ADDENDUM NO. CC-1

TELEGRAPH DISTRICT
401 BUILDING RENOVATION
LINCOLN, NEBRASKA
DLR GROUP PROJECT NO. 10-16202-00

February 26, 2016

ED1.0

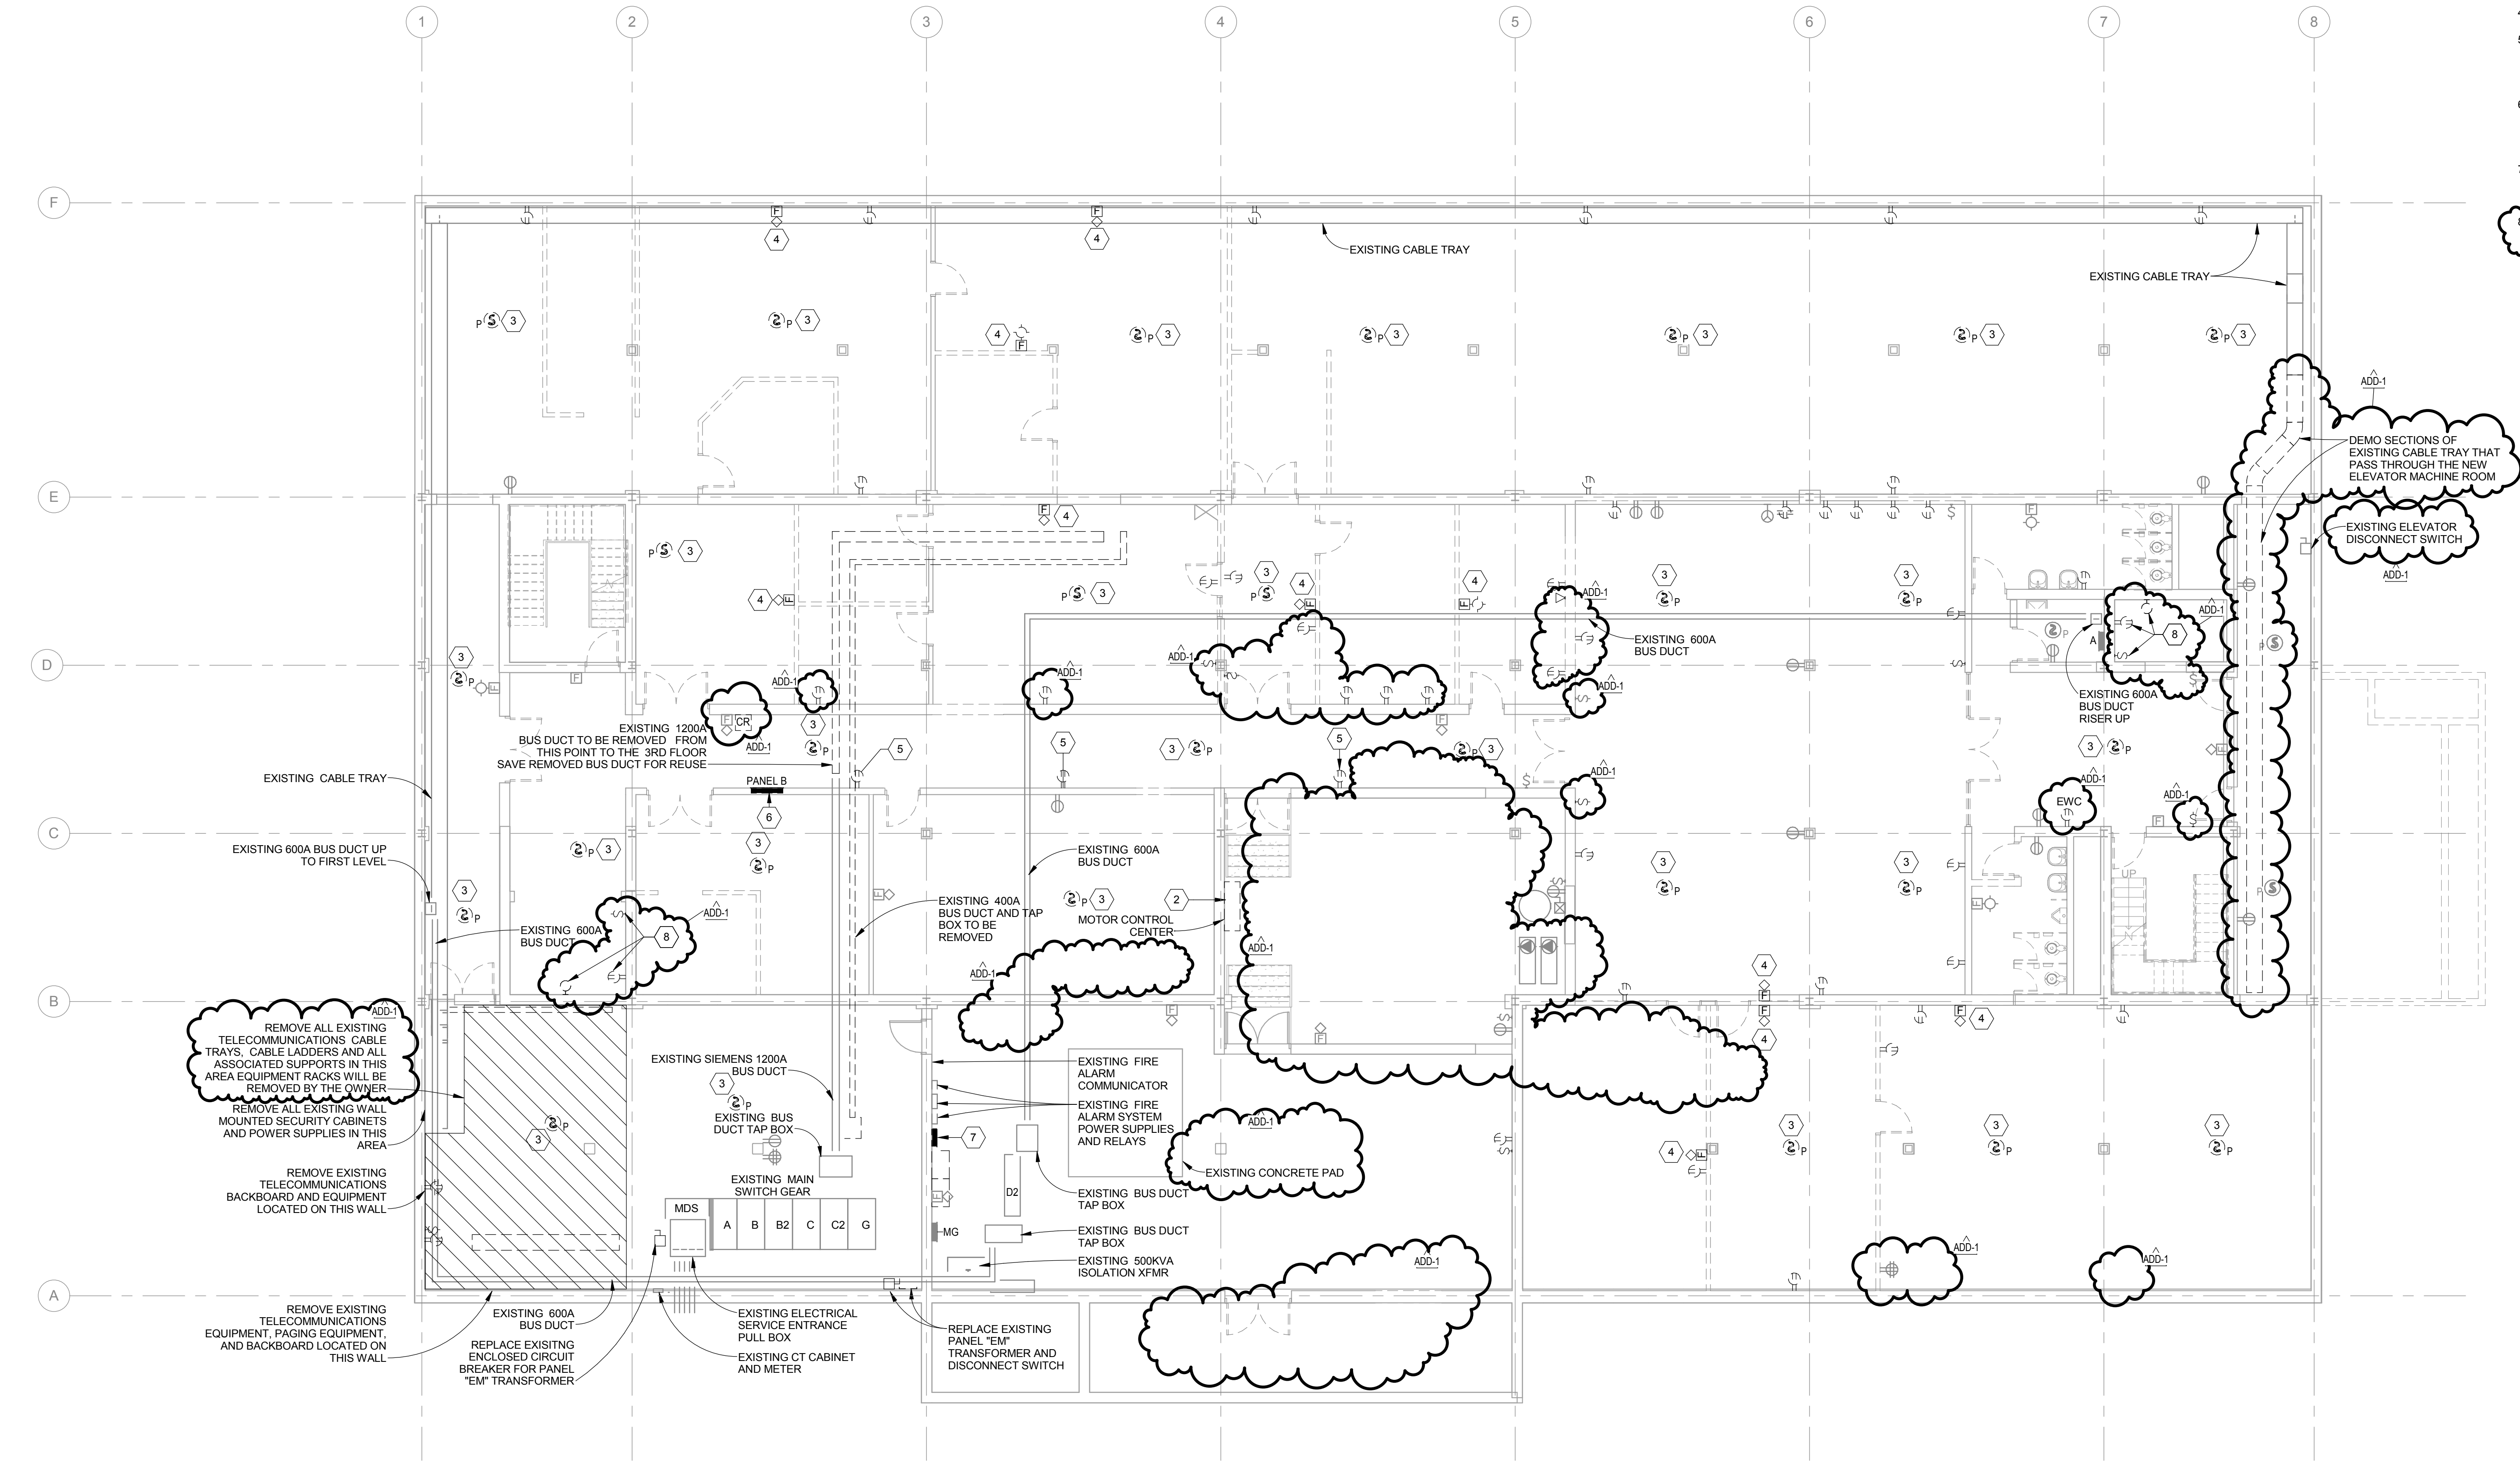
ITEM NO. 29 DRAWING ED1.0 POWER AND SYSTEMS DEMOLITION PLAN, BASEMENT LEVEL

- A. Revise drawing as shown in the attachment ED1.0 for modifications to the demolition plan.

POWER AND SYSTEMS DEMOLITION PLAN, SECOND LEVEL
SCALE: 1/8" = 1'-0"

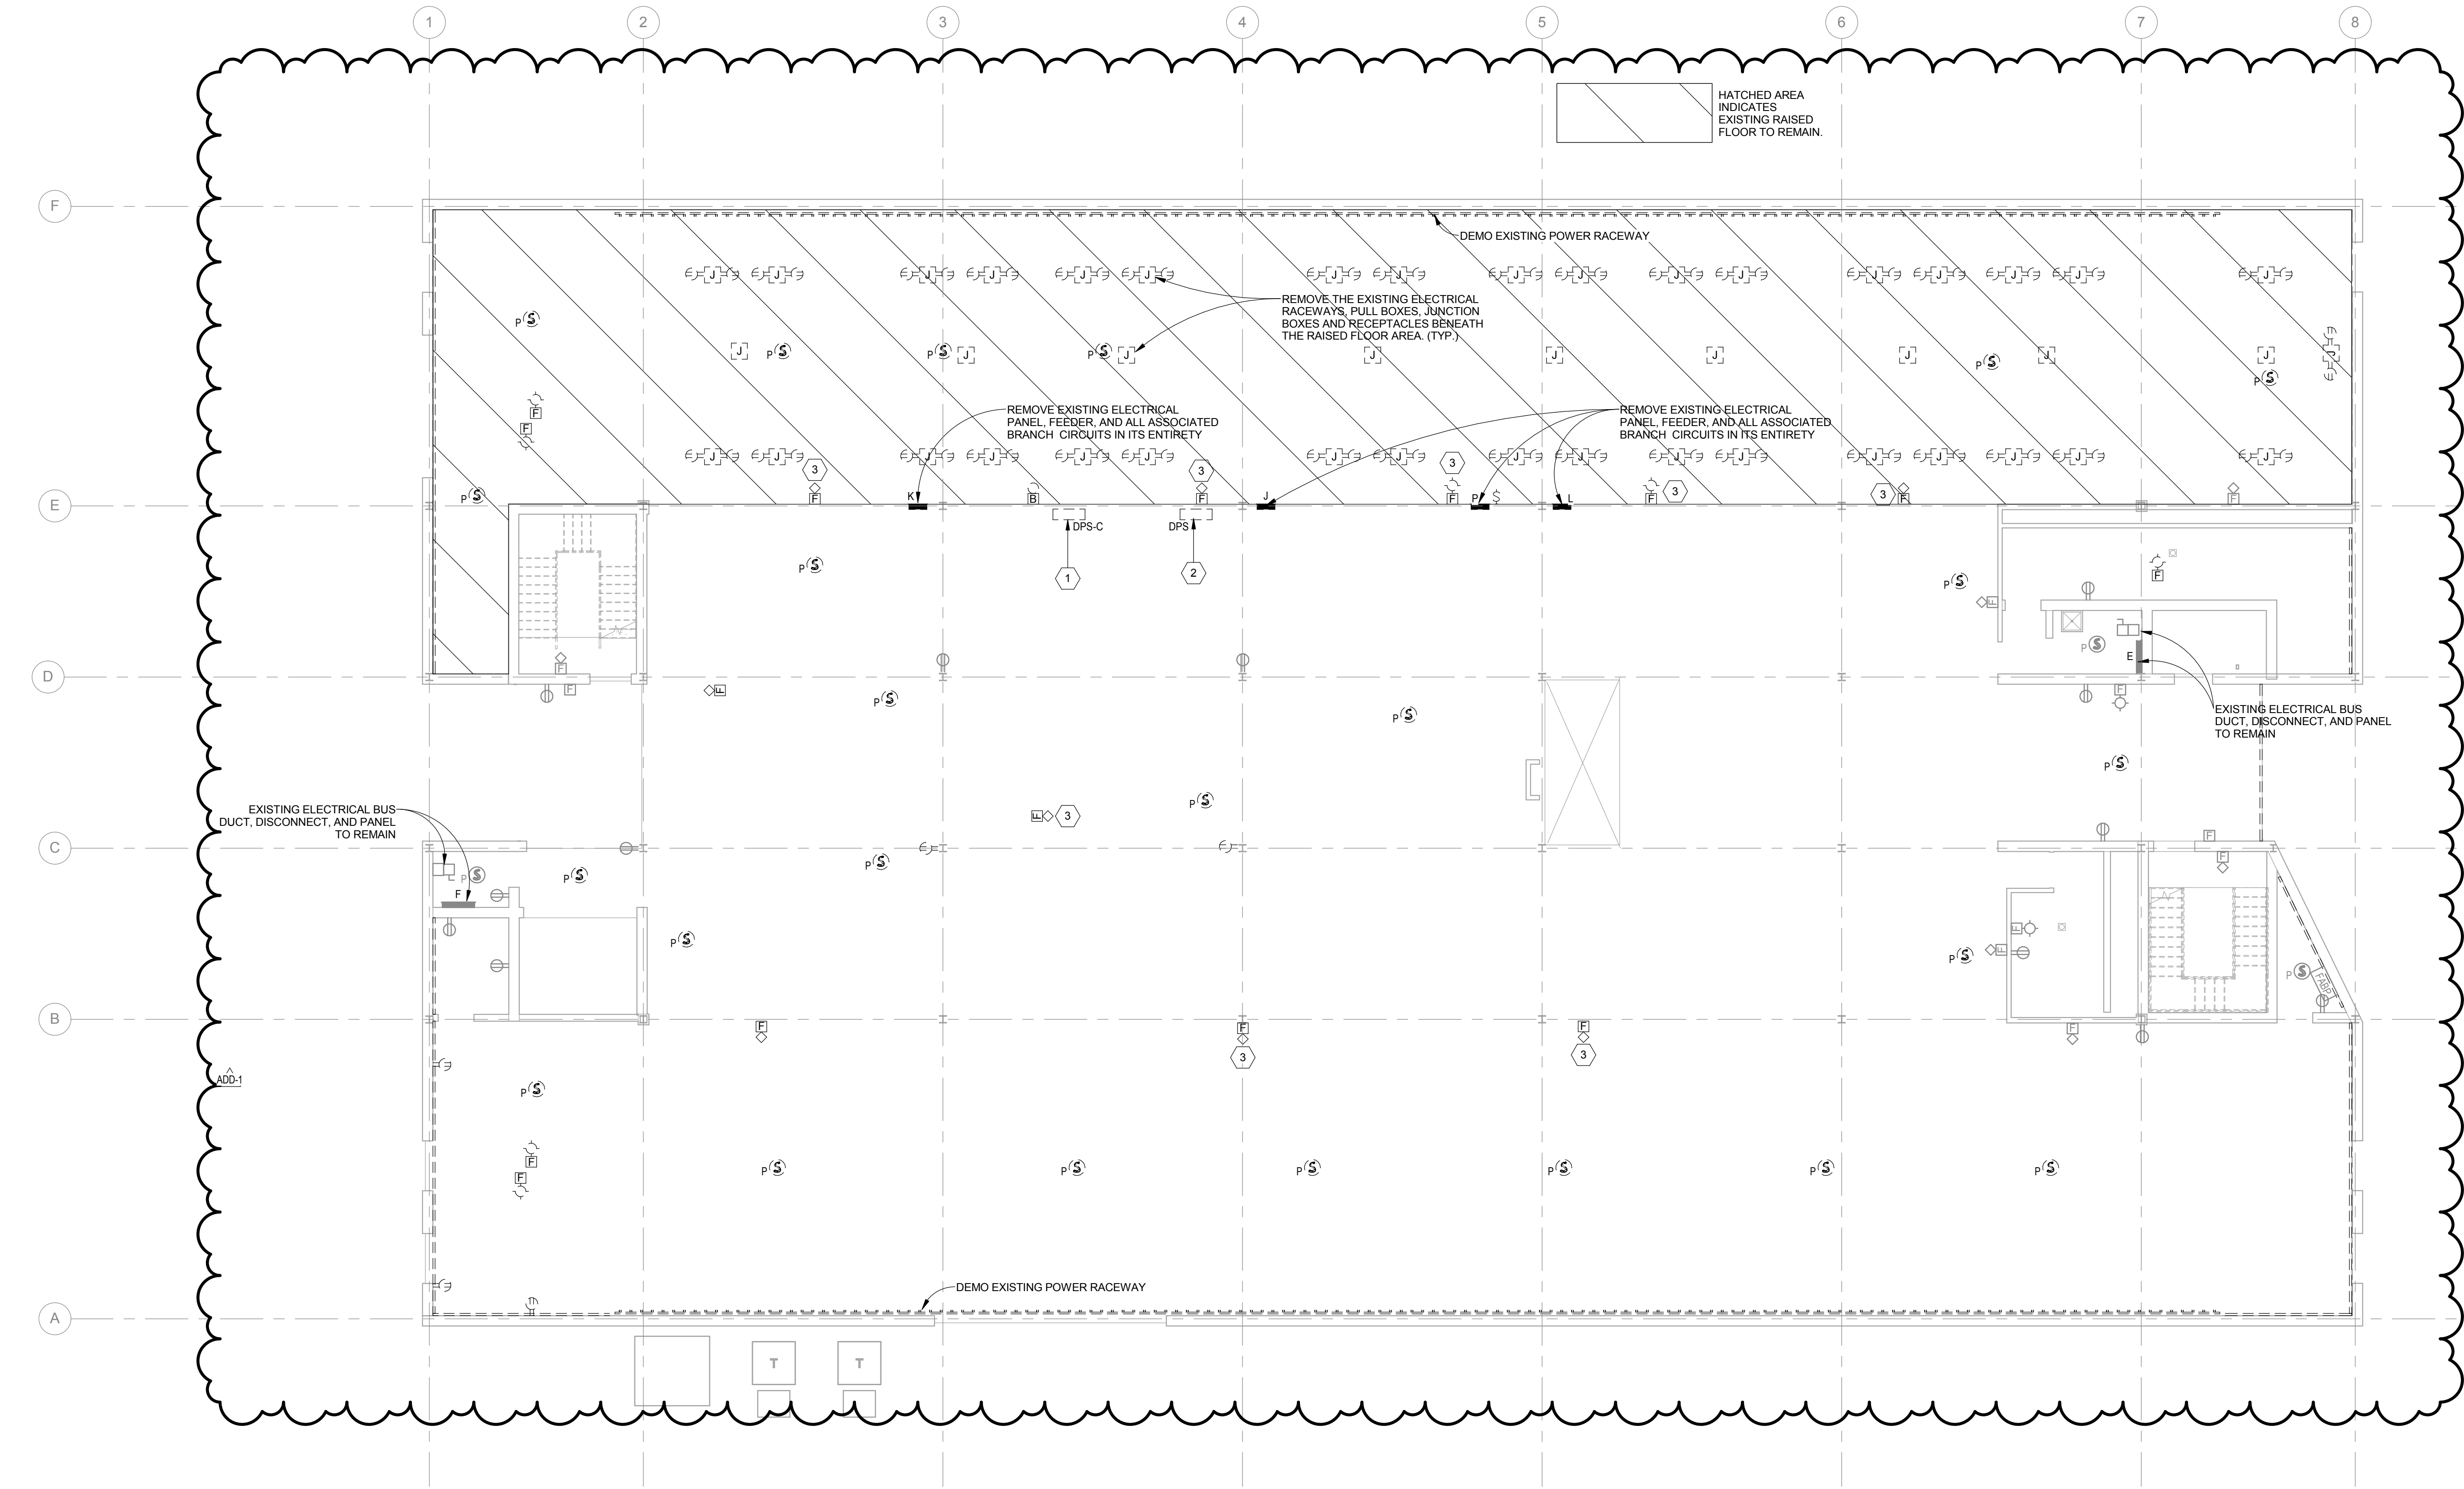
ITEM NO. 30 DRAWING ED1.2 POWER AND SYSTEMS DEMOLITION PLAN, SECOND LEVEL

- A. Revise drawing as shown in the attachment ED1.2 for modifications to the demolition plan.

POWER AND SYSTEMS DEMOLITION PLAN, THIRD LEVEL

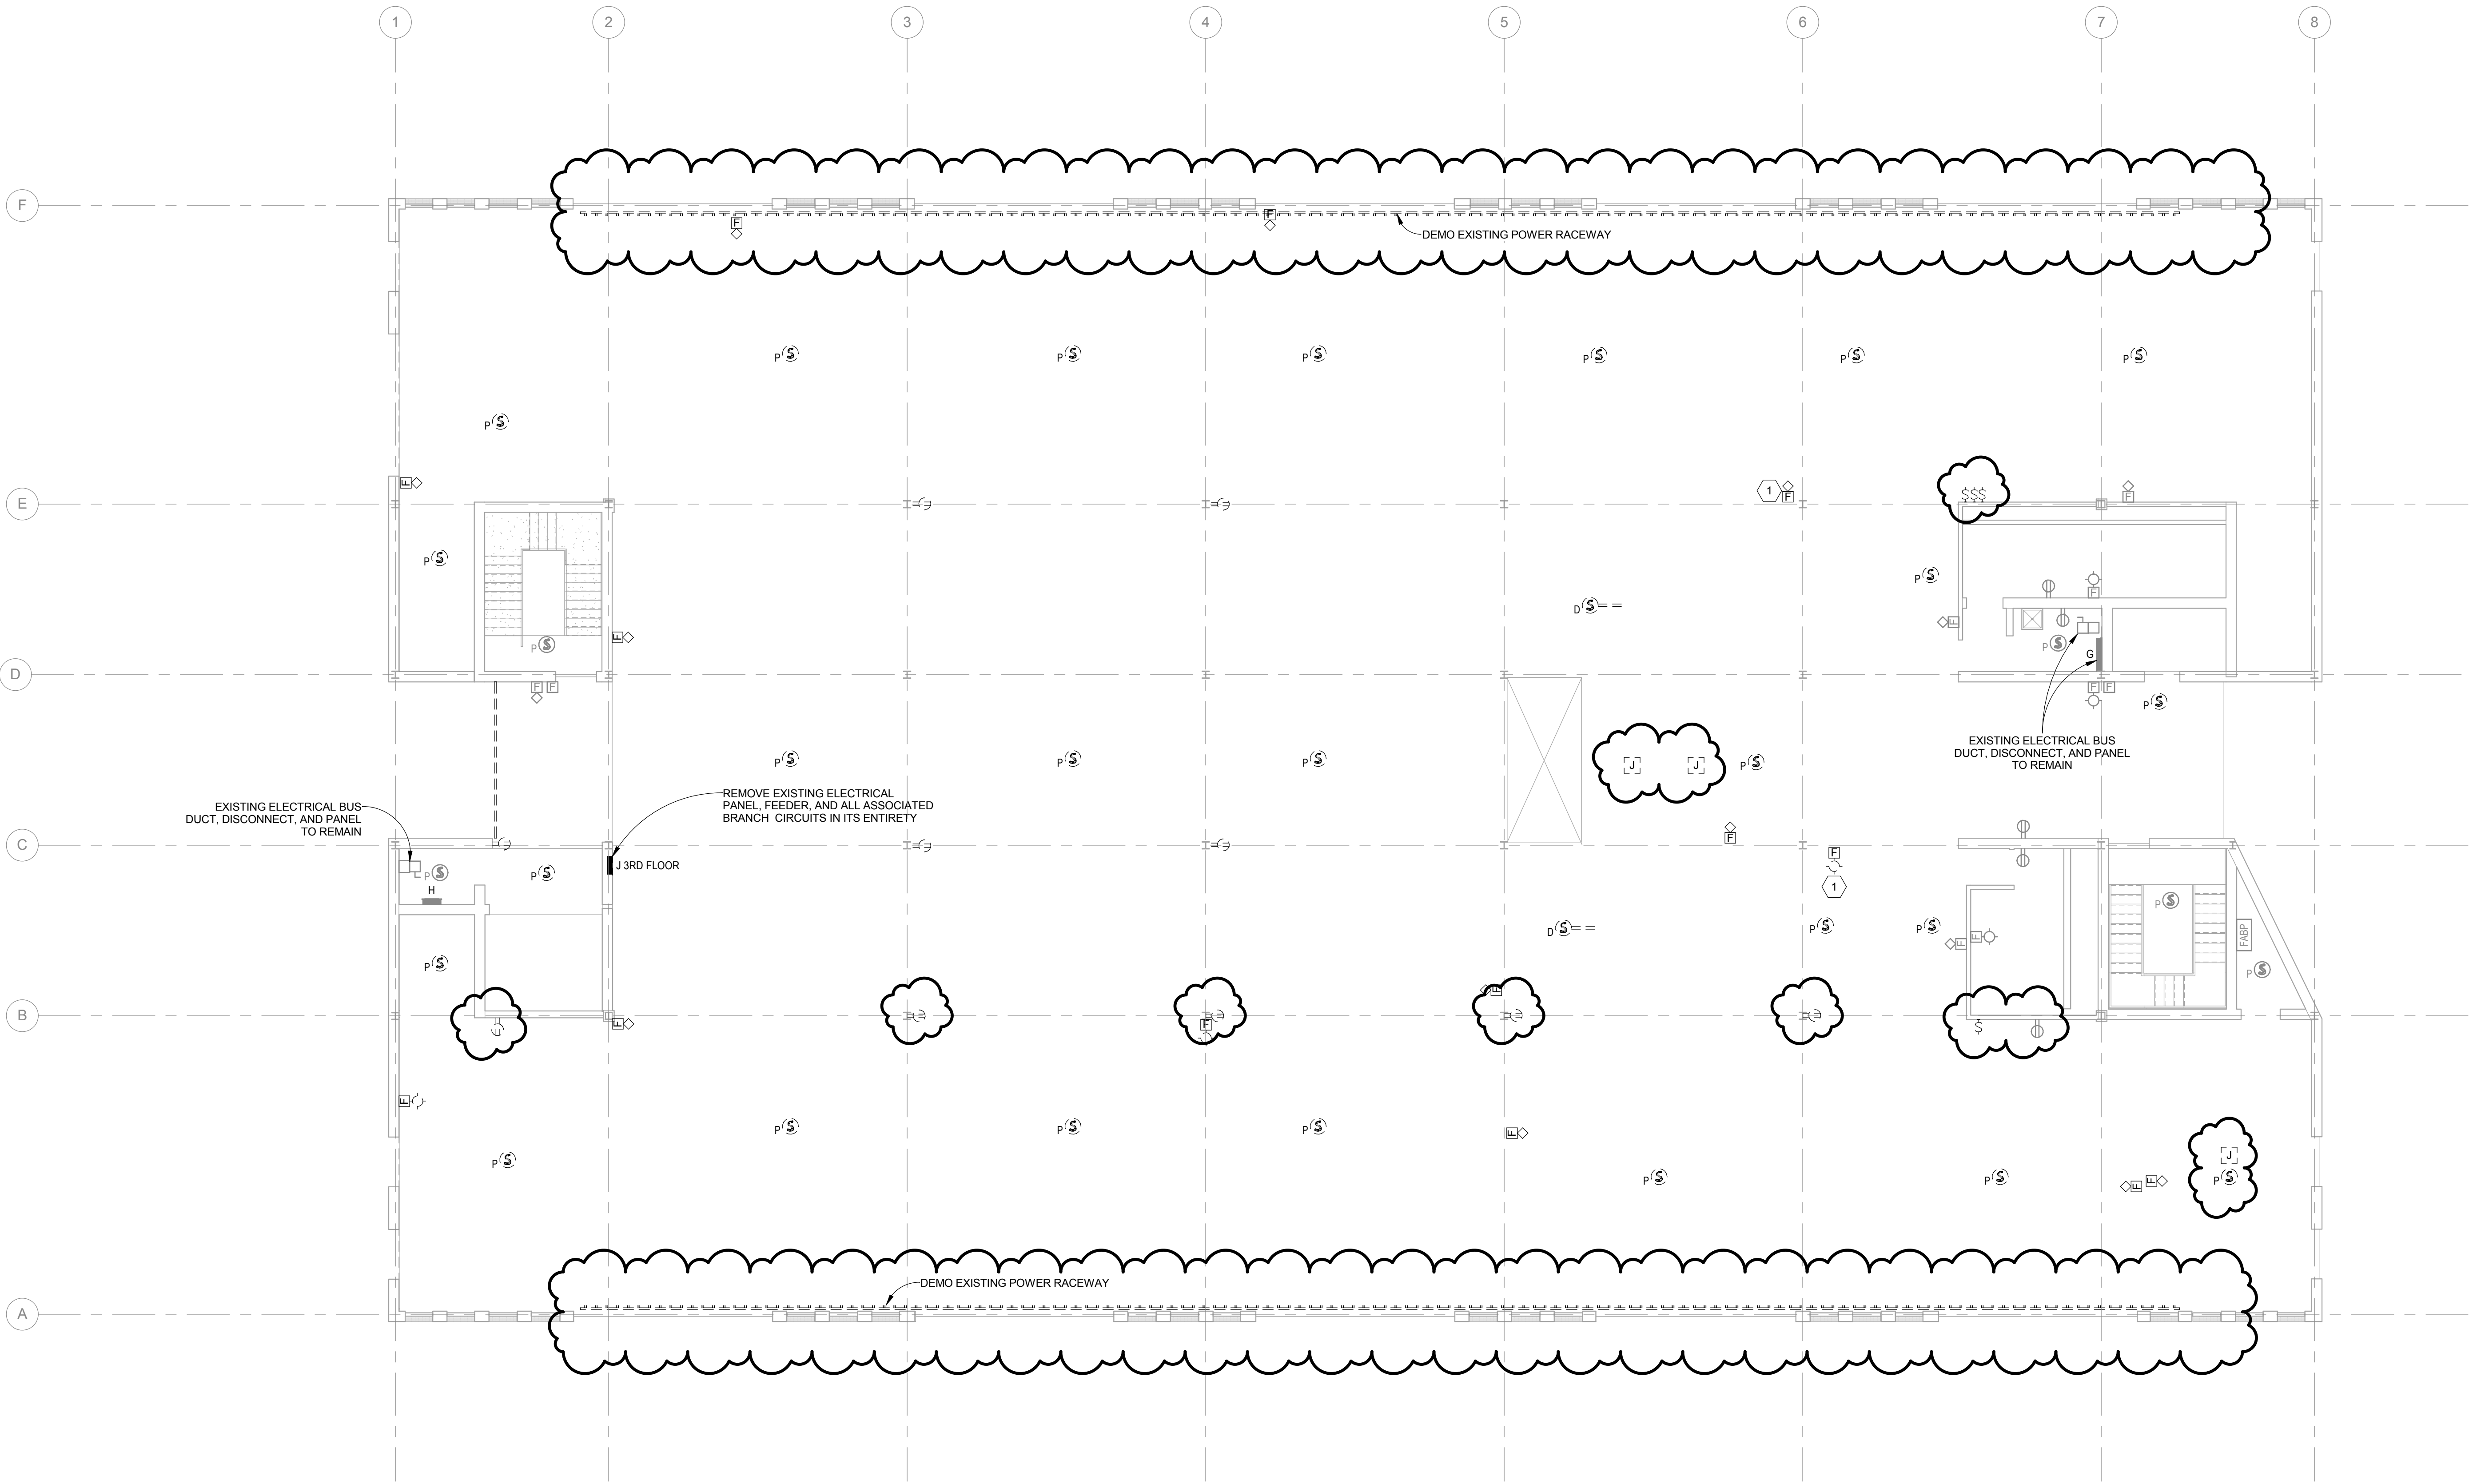
ITEM NO. 31 DRAWING ED1.3 POWER AND SYSTEMS DEMO PLAN, THIRD LEVEL

- A. Revise drawing as shown in the attachment ED1.3 for modifications to the demolition plan.
